**GUARDIAN**
REAL ESTATE SERVICES LLC

DESIGN ADVICE
REQUEST 002
JUNE 2015

BLOCK 290

DAR 01 comments | challenges

nw quimby street

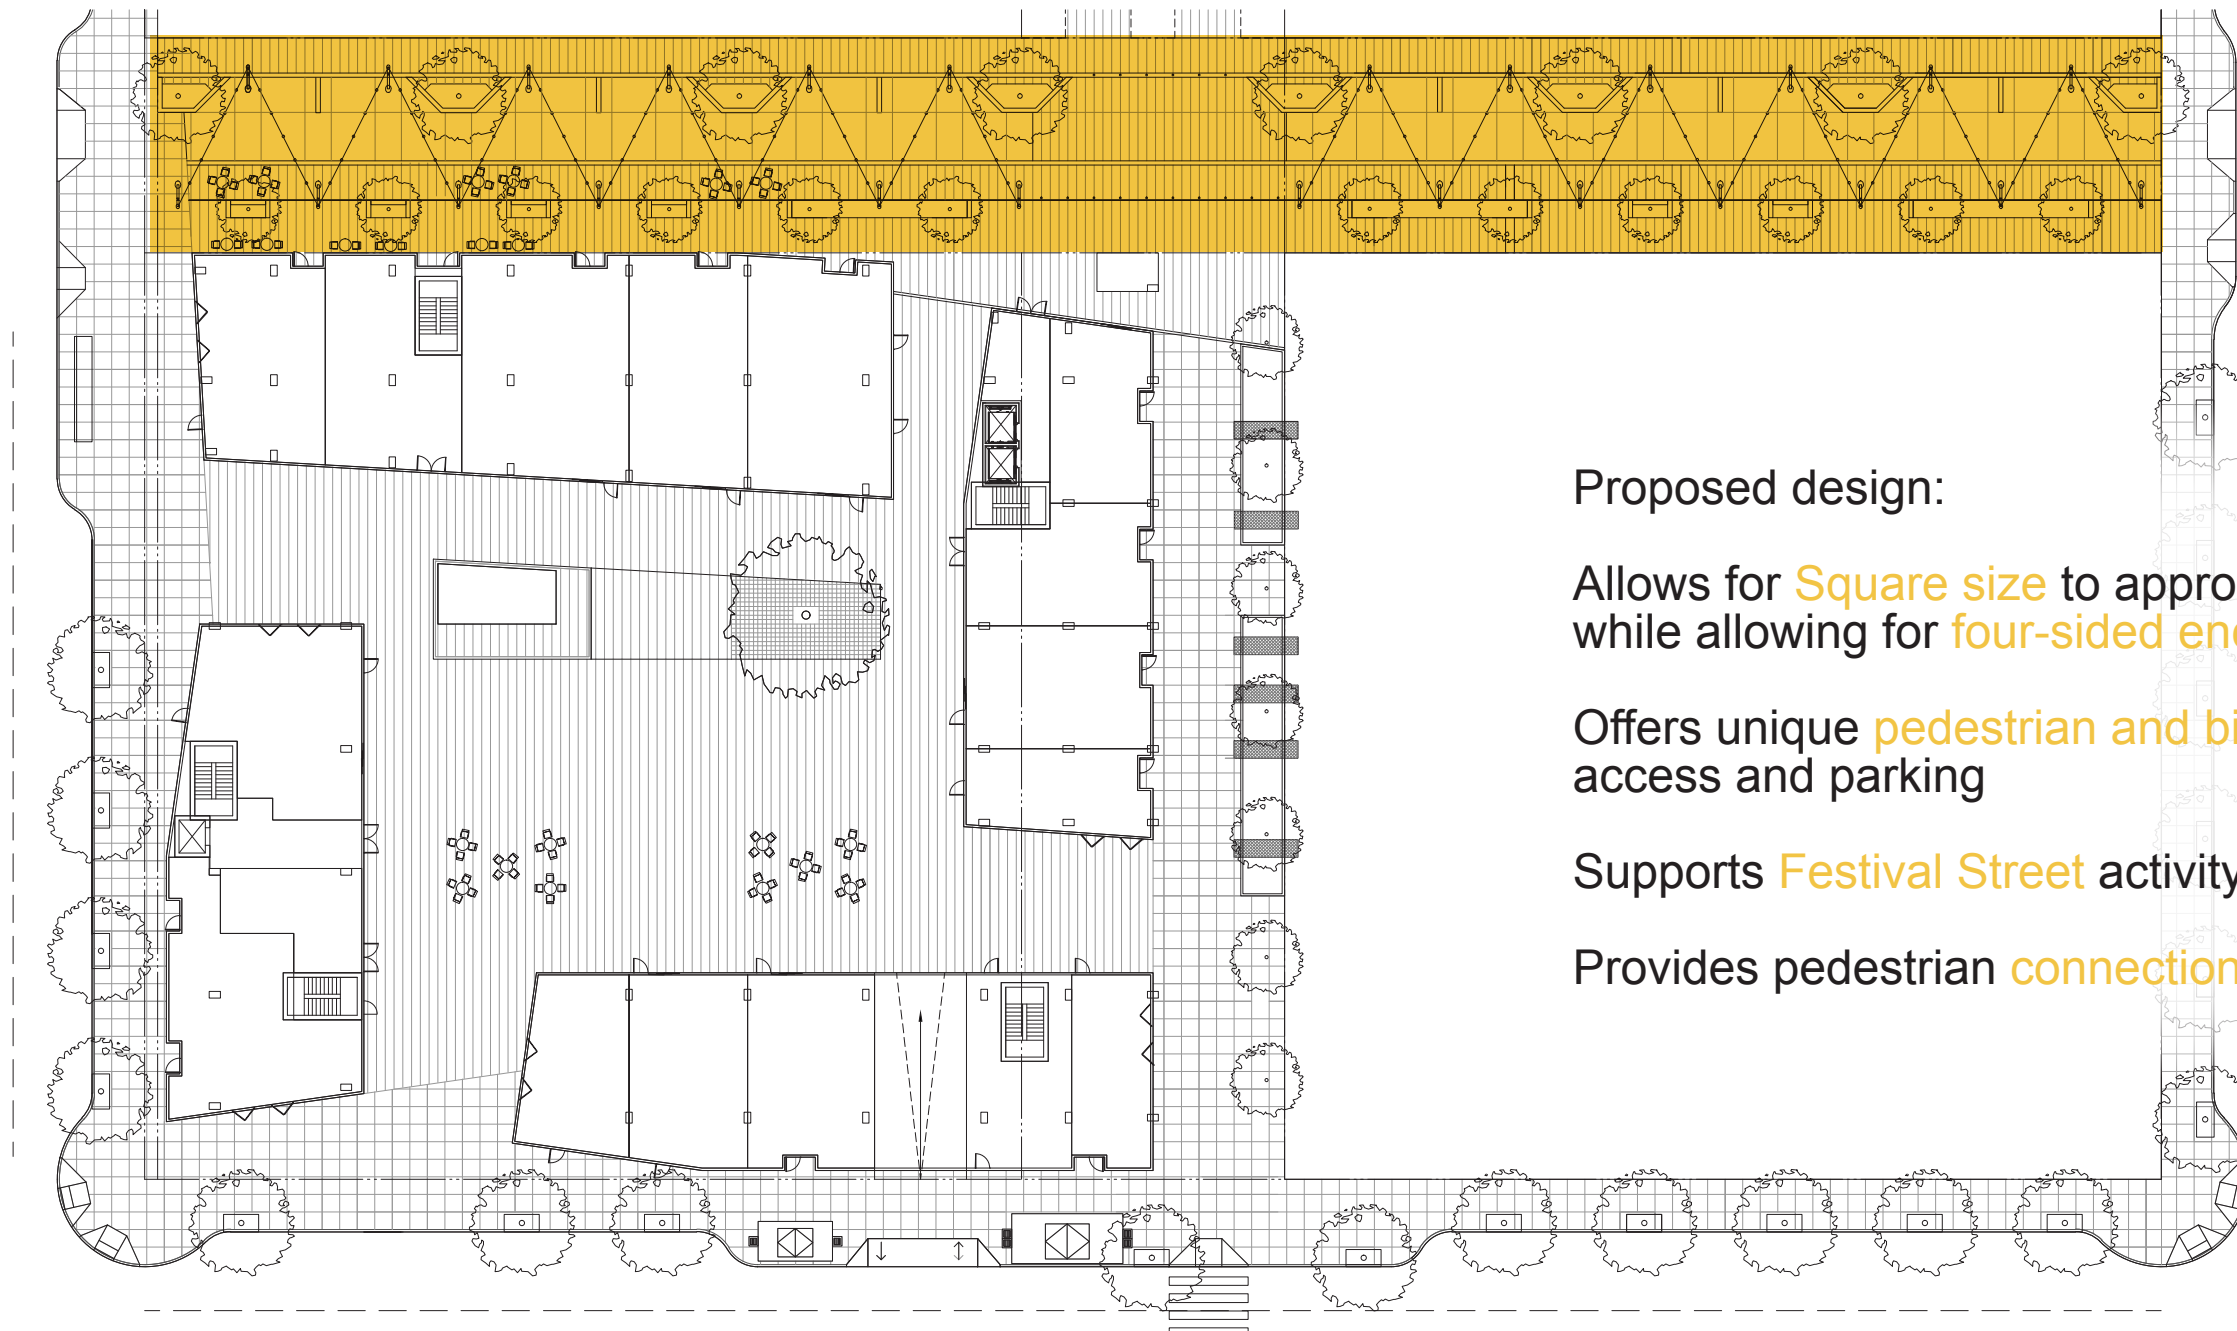
4. Address the function of NW Quimby St. to support pedestrian and bicycle circulation and integrate vehicular uses.

Proposed design:

Allows for **Square size** to approximate Master Plan requirements while allowing for **four-sided enclosure**

Offers unique **pedestrian and bicycle** realm with limited vehicular access and parking

Supports **Festival Street** activity

Provides pedestrian **connection** to the **park** and the **square**
